Planning Commission
Council Chambers
September 20, 2022 – 6:00 p.m.
233 South Main Street, Monroe, Ohio

TO: Members of the Monroe Planning Commission
FROM: Kameryn Jones
Assistant Development Director

DATE: September 20, 2022
RE: Information Packet for September 20, 2022 Planning Commission Meeting at 6:00 p.m.

I. Case No. 2022-9-9— Consideration of Site Plan Application for an Office Warehouse Facility on Baker Drive.

SITE LAYOUT/PARKING/UTILITIES PLAN
BAKER DRIVE STORAGE FACILITY
BAKER DRIVE
CITY OF MONROE
WARREN COUNTY, OHIO

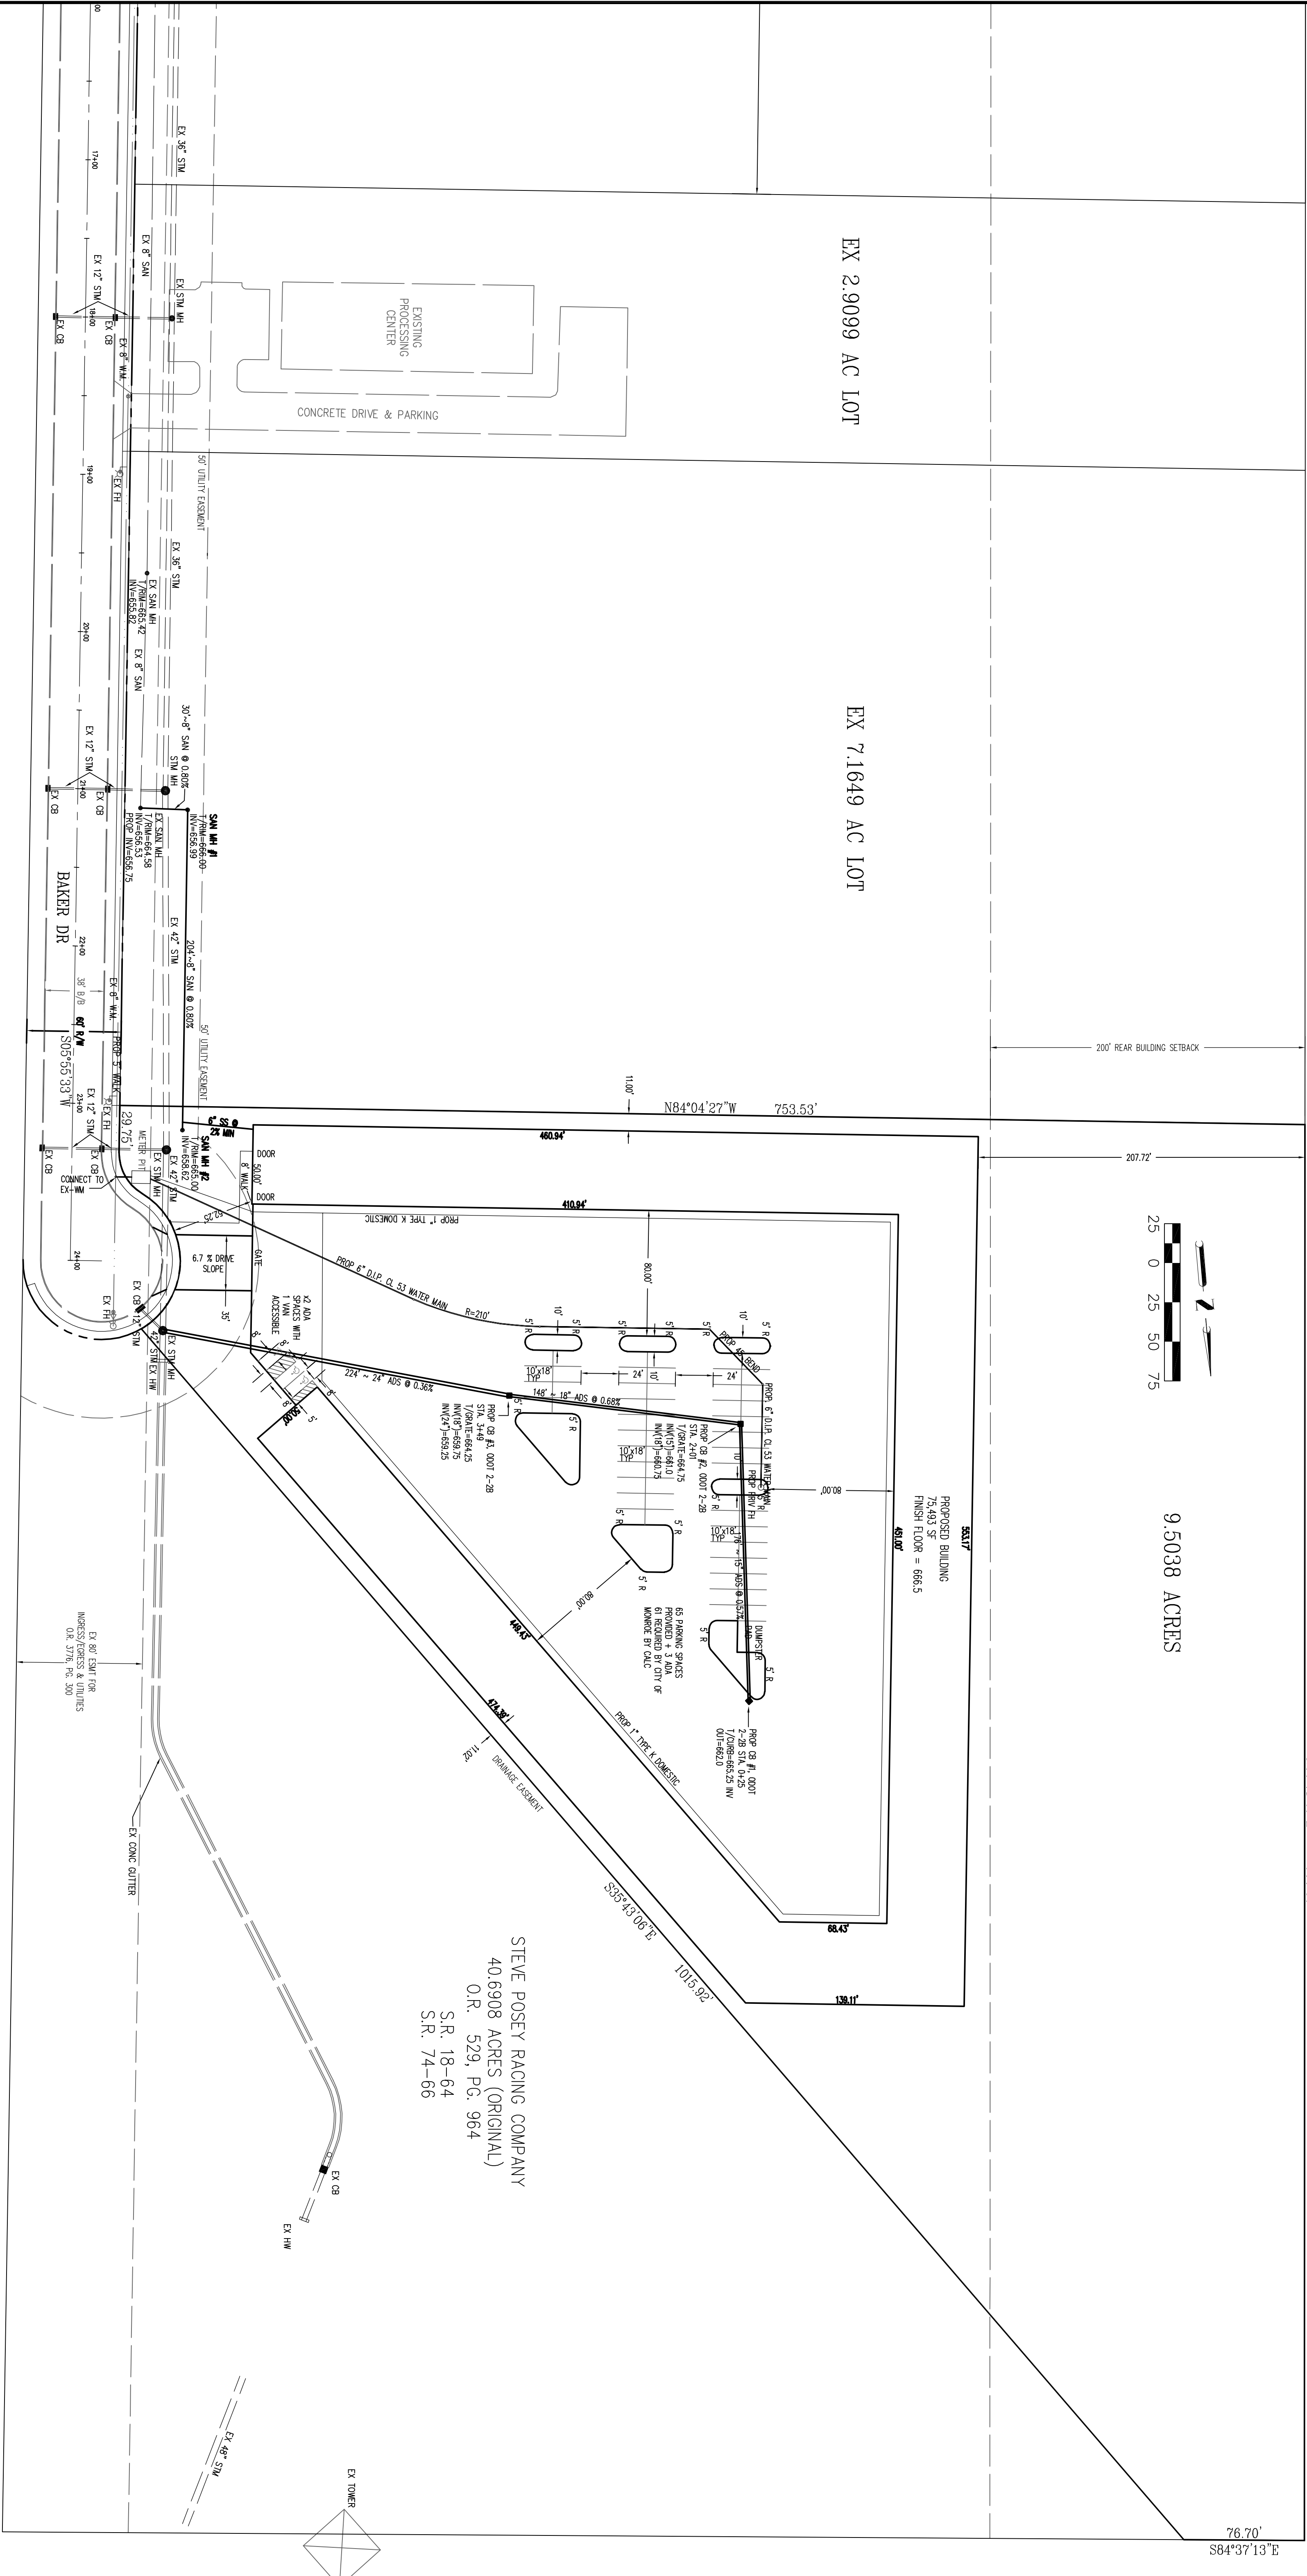
- 10% variance would permit no more than 66 parking stalls.
 - 68 parking stalls proposed. Parking would need to be reduced to no more than 66. Please revise.

- **Street Trees:**
 - Street trees are required to be planted in the tree lawn between the public walk and curb.
 - Street trees are proposed behind the sidewalk in the front yard of the site. Please revise.

- None are shown. Please revise.
 - A minimum 20% of the required front yard must be landscaped, with a minimum 6-foot wide landscape bed along the right-of-way.

- Please provide the width of front yard landscaping bed along the sidewalk at the front of the development.
 - Buffer Type D required along west side.

- Planning Commission make a determination regarding the required buffer yard along the west side of the development and
 - whether to require installation of buffer as required per code **or**
 - to permit the proposed buffer plan as shown, using existing vegetation with a limited amount of new plantings under a buffer easement, to protect and maintain the existing buffer, as approved by staff to be recorded by the applicant.
- The applicant will revise the parking plan to reduce parking numbers to no more than 66 parking spaces and incorporate the missing parking islands.
- The applicant will revise the landscape plan to address staff report comments in regards to street tree placement and landscaping for missing parking islands.

- The applicant understands minimum size and species requirements related to landscaping must be met.
- The applicant will revise architectural drawings to address staff report comments.
- The applicant will revise the lighting plan to address staff report comments.
- The applicant understands ground mounted or rooftop equipment must be screened according to code requirements.
- The applicant will be responsible for maintenance (mowing, etc.) of the right-of-way adjacent to the developed site once improvements are complete.
- All other Staff comments to be met and any future Engineering review requirements be met.
- A GIS compatible file of finalized plans be submitted.

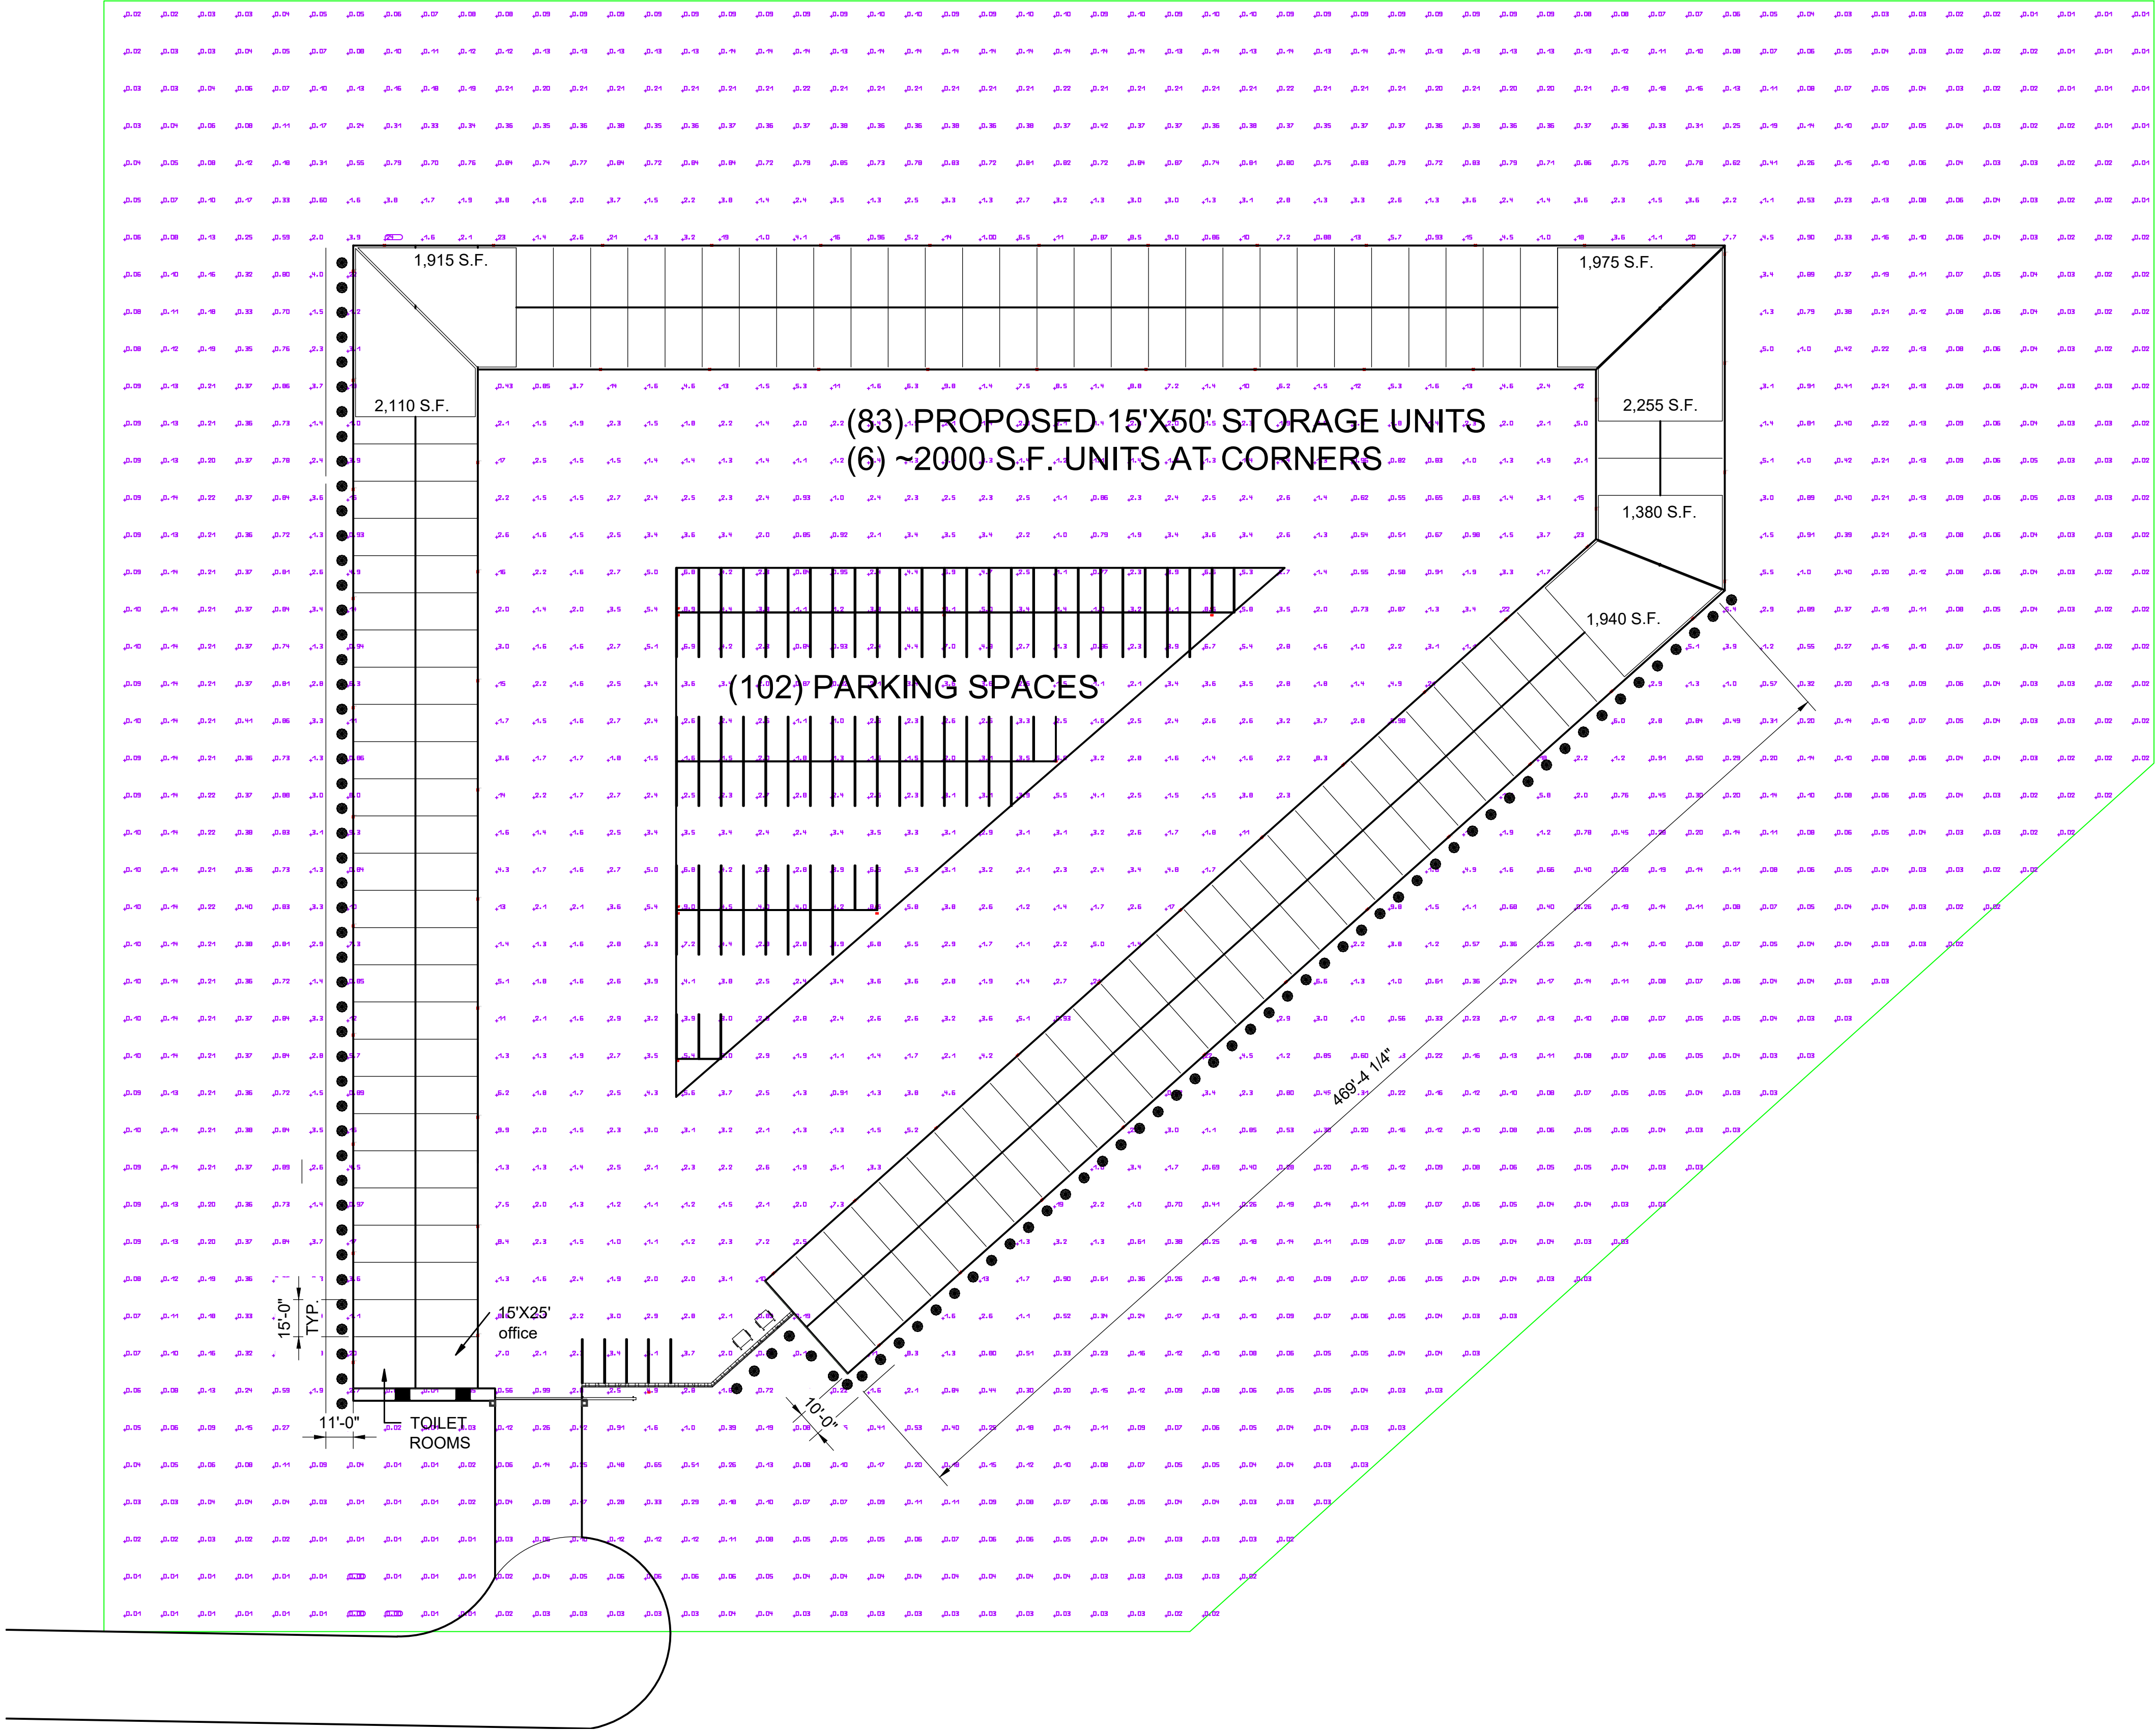
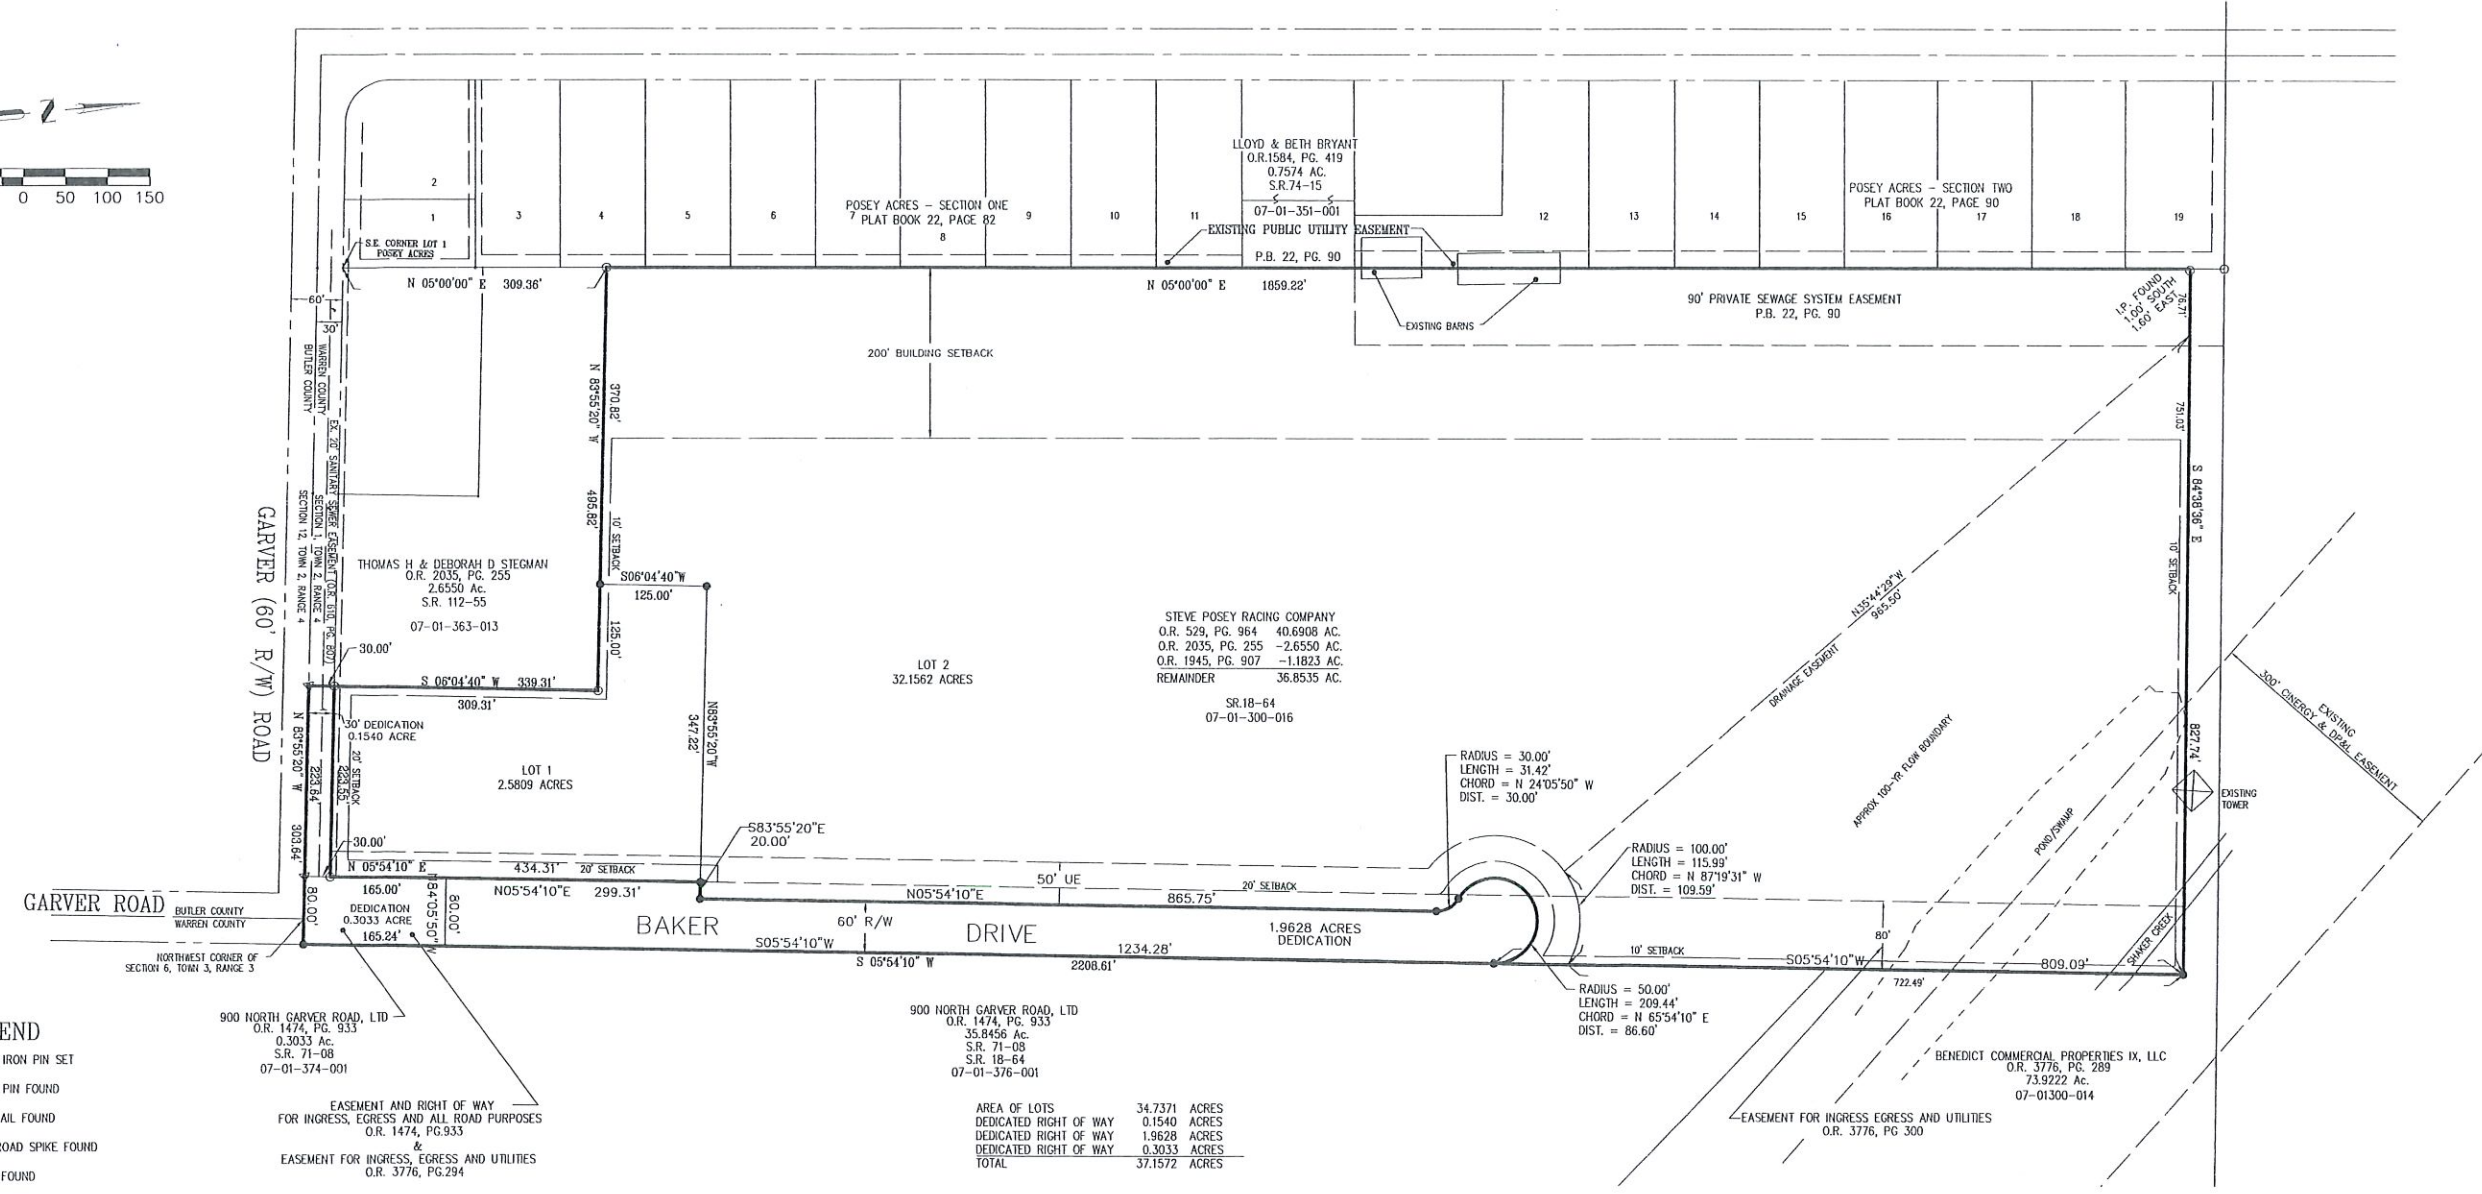
- The provided photometric plan appears to use an outdated site plan. Please revise.
 - The site appears to be underlit at the entrance at Baker Drive and along the sidewalk along the building on the south side. Please revise.

- The site appears to be overlit in select areas along the southern property line. Please revise.
